**CITY OF BEAUFORT  
DESIGN REVIEW BOARD  
Staff Report  
Meeting of May 12, 2016**

**Case Number:** 16-02 DRB.3  
**Project:** Home2 by Hilton  
**Property Address:** Parris Island Gateway & County Shed Road  
**Parcel #:** R120 026 000 0160 0000 (a portion of this parcel)  
**Zoning:** Highway Commercial  
**Design District:** US 21 Design District  
**Type of Review:** **Final Review – New Construction**

**SHEET C101**

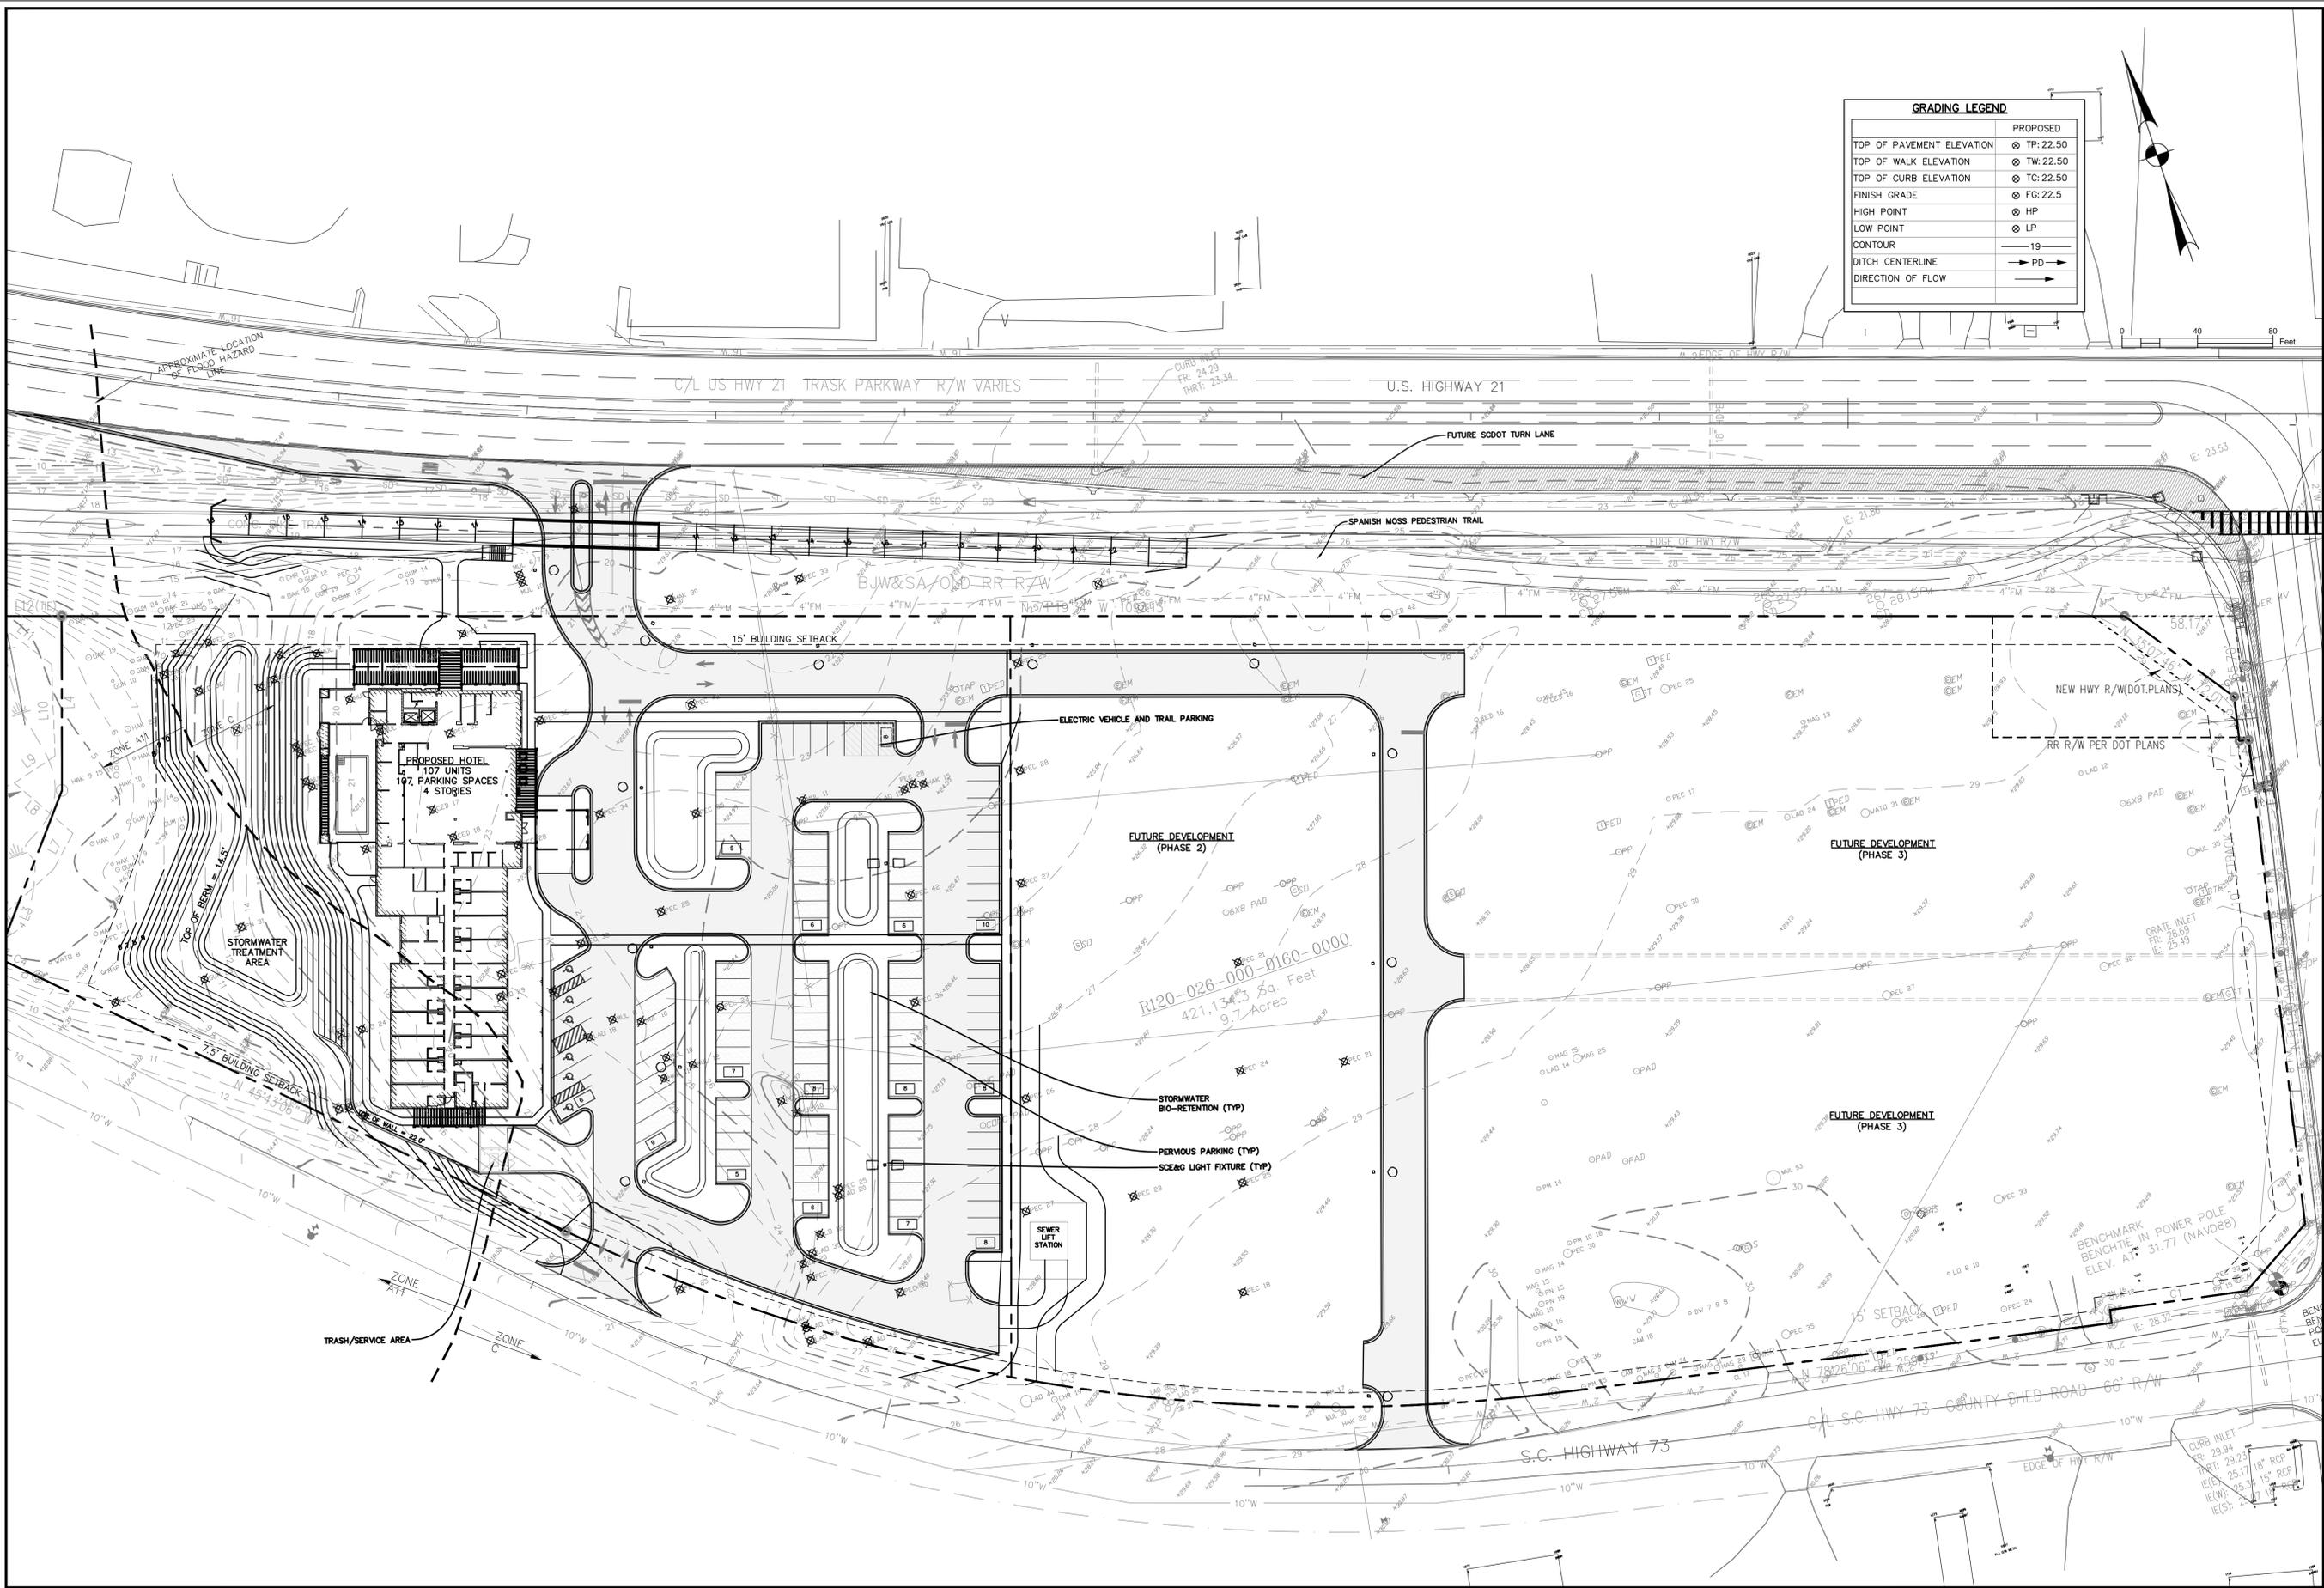
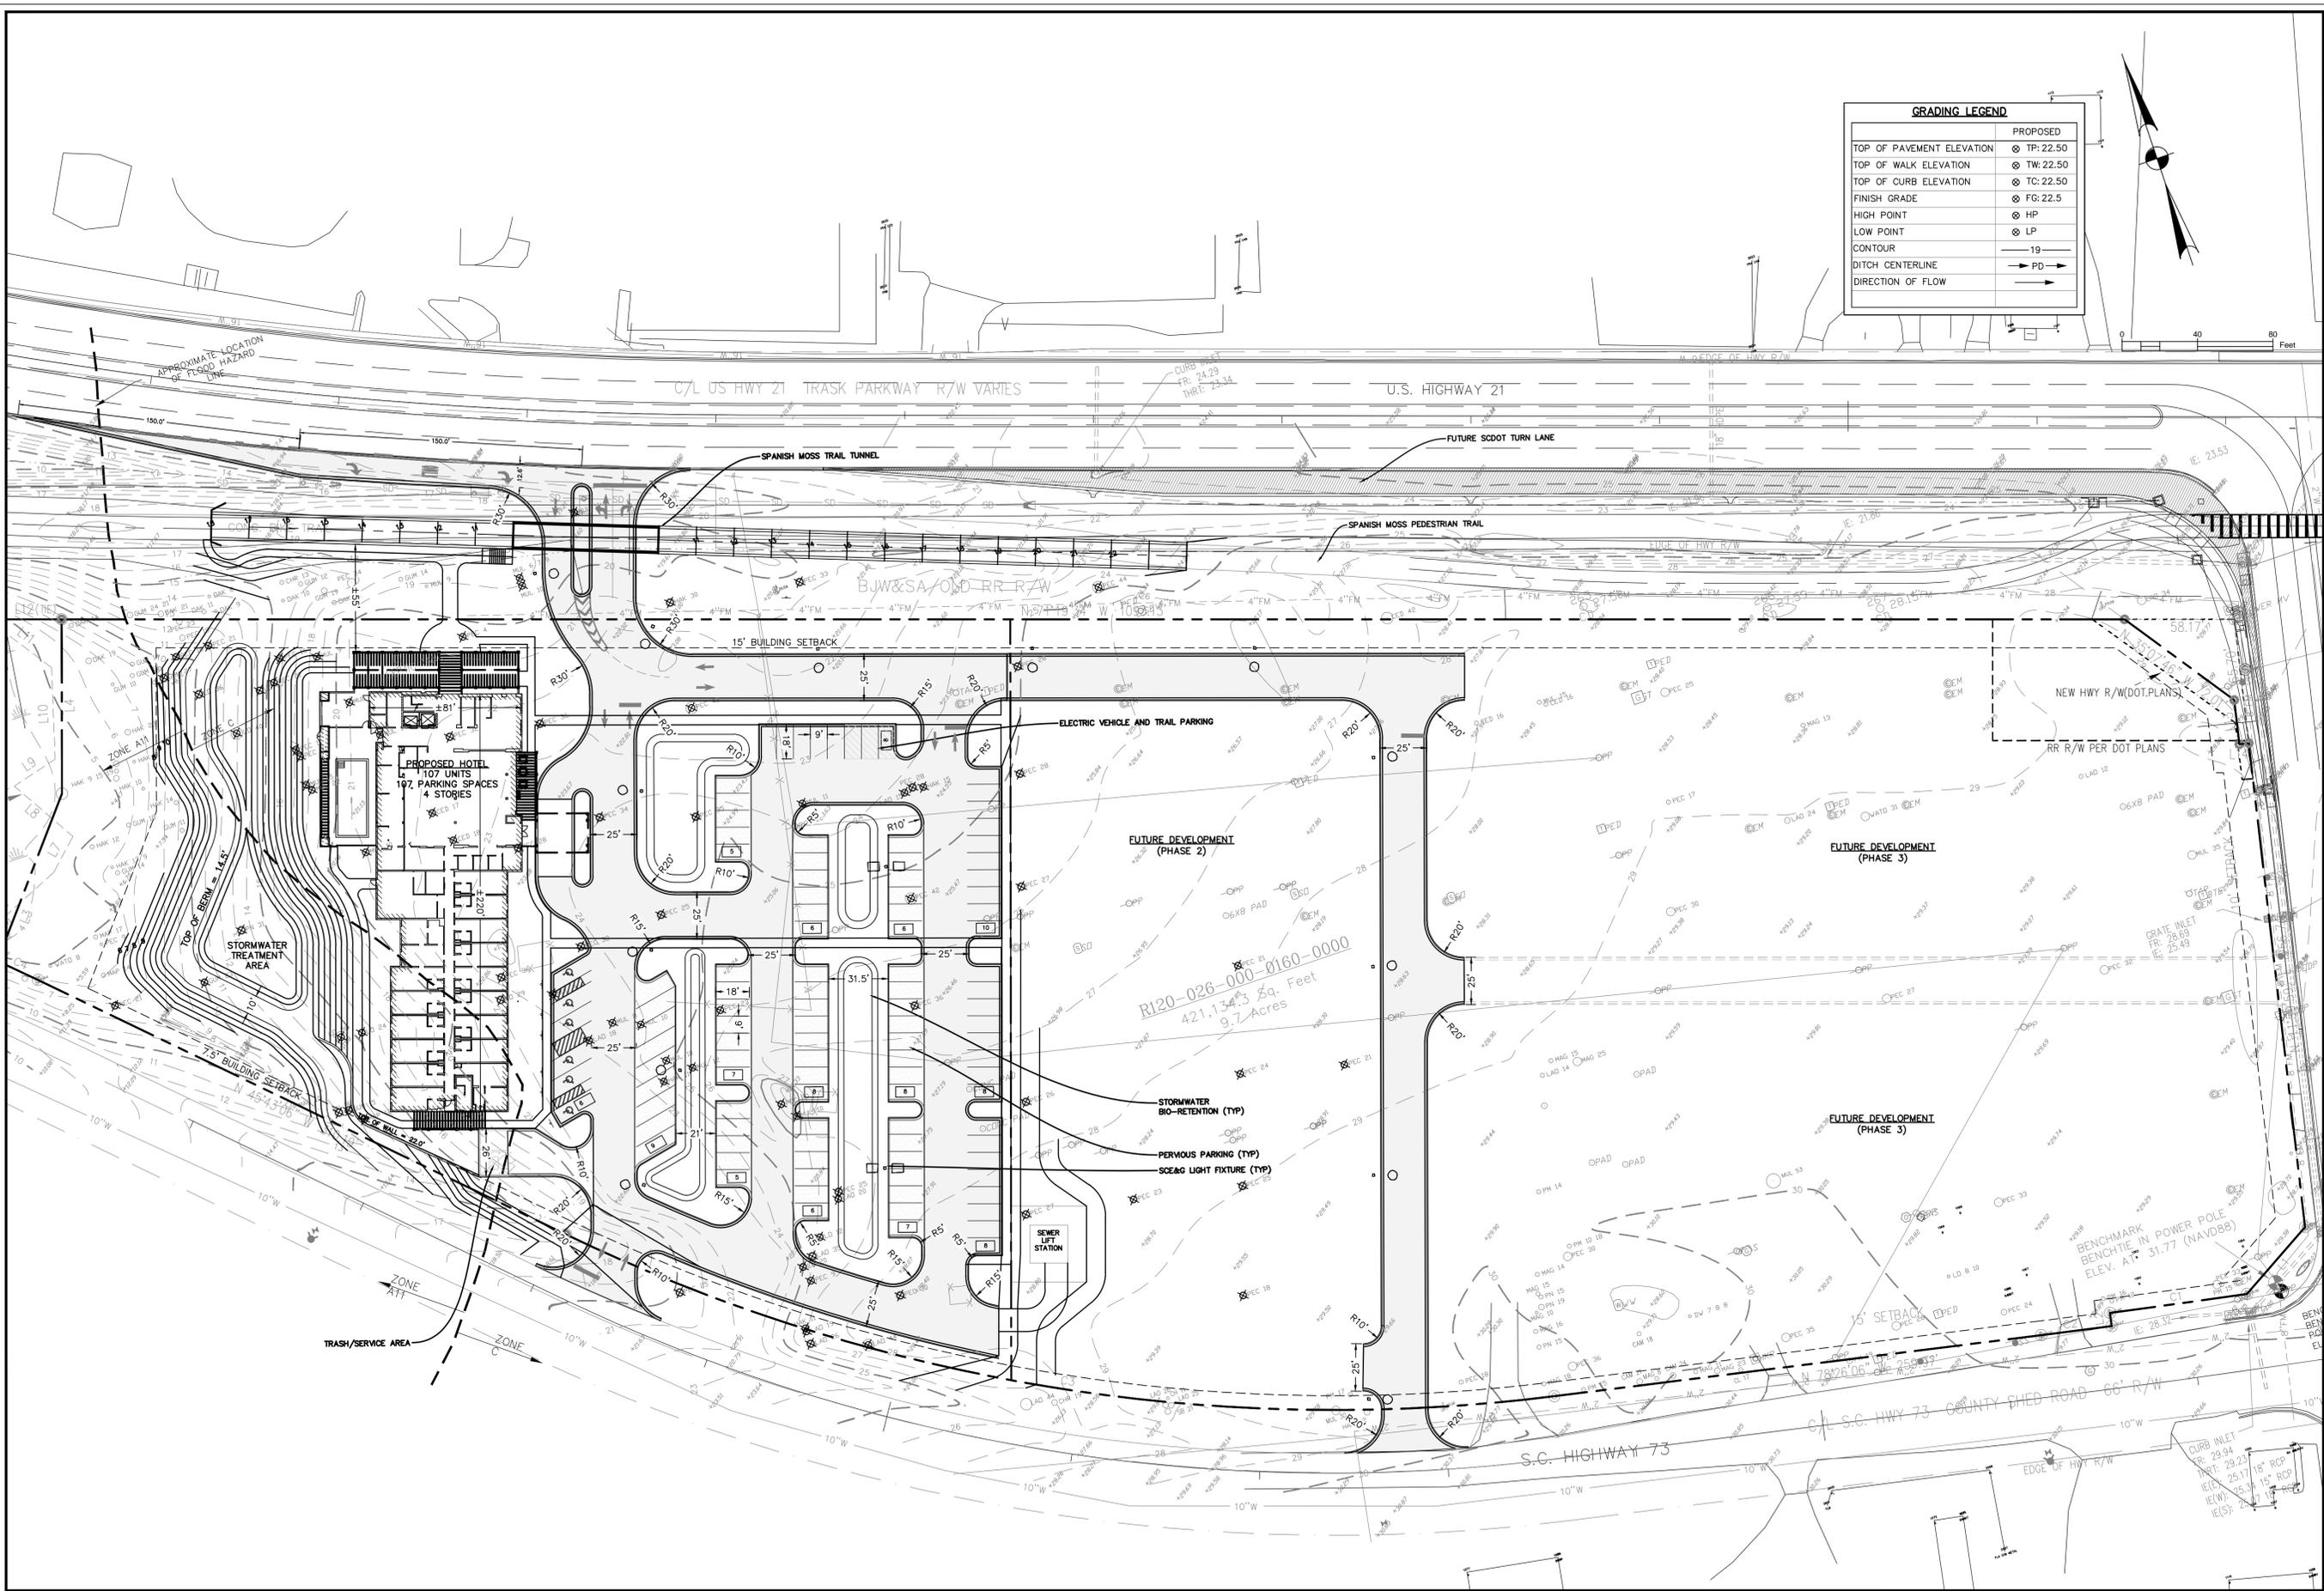
- Trees:
  - Arborist report states trees in stormwater treatment area to be preserved. Trees shown on site plan, sheet C101 as being removed. Listing with grading elevations:

- 36" LO Existing grade: +10 Proposed grade: +14
    - 40" LO Existing grade: +13 Proposed grade: +12
    - 20" LO Existing grade: +14.5 Proposed grade: +14.5

- 38" LO Existing grade: +14 Proposed grade: +20
    - 24" LO Existing grade: +15.5 Proposed grade: +22
  - The grading for the stormwater treatment area should be revised to preserve these trees as recommended. It does not appear that tree location nor Arborist report was considered in design.

Plan View  
Scale: 1" = 30'

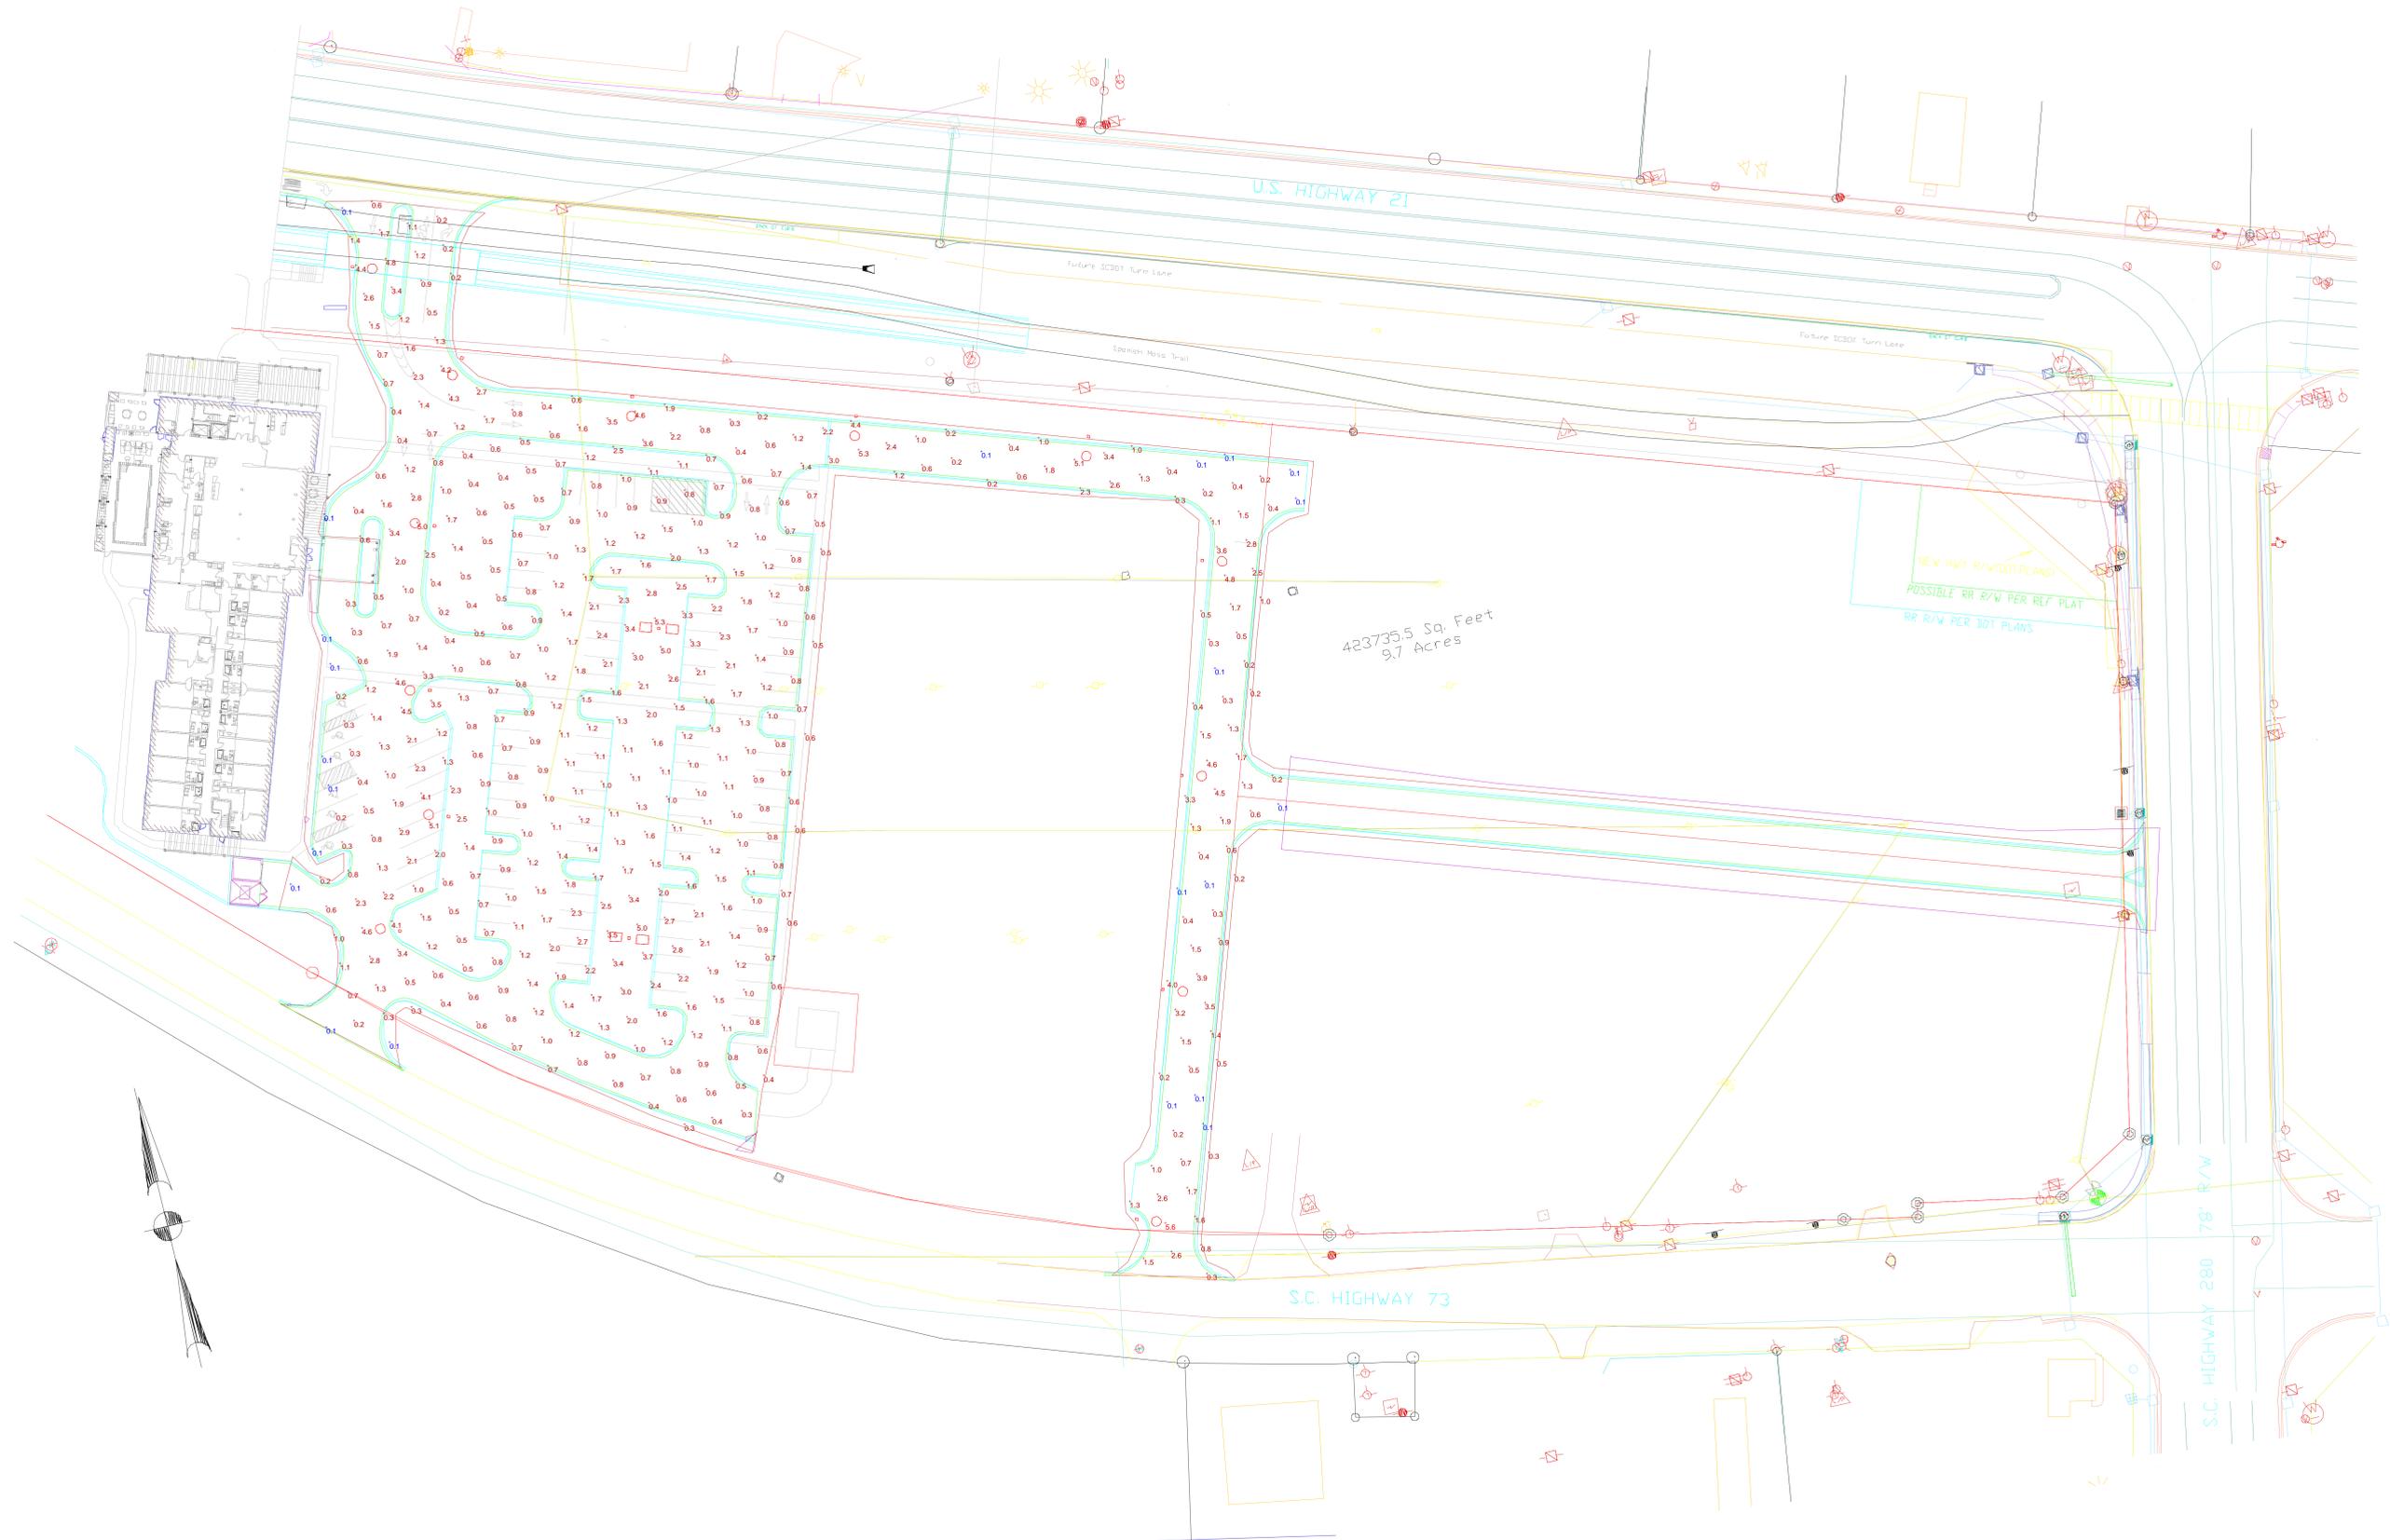
- For the American Electric lights in the middle of the parking area, please provide details – cut sheet, color, pole/mounting height, pole material.

- Where are the bike racks located?
- A lighting plan, showing building and site lighting, will be required. Full-cut off fixtures are required for parking lot lighting.
